Notice of Intent

Type of Action: Plug and Abandonment

Well Name: EAGLE 35 E FEDERAL

Plug Abandonment NOI Proposed

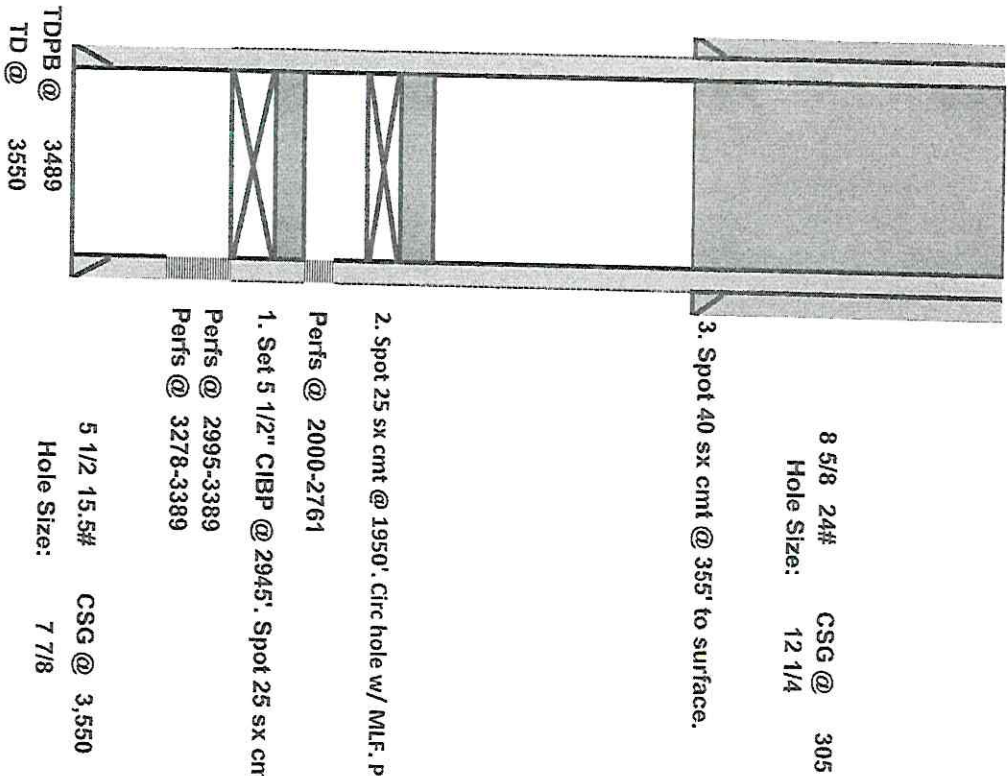
1. Set 5 1/2" CIBP @ 2945'. Spot 25 sx cmt @ 2945-^{2693'}2745'. WOC & Tag
2. Spot 25 sx cmt @ 1950'. Circ hole w/ MLF. Pressure test csg. Spot 25 sx cmt @ 1950-^{1763'}1750'.
3. Spot 40 sx cmt @ 355' to surface.
4. Cut off well head, verify cmt @ surface, weld on Dry Hole Marker.

High Cave
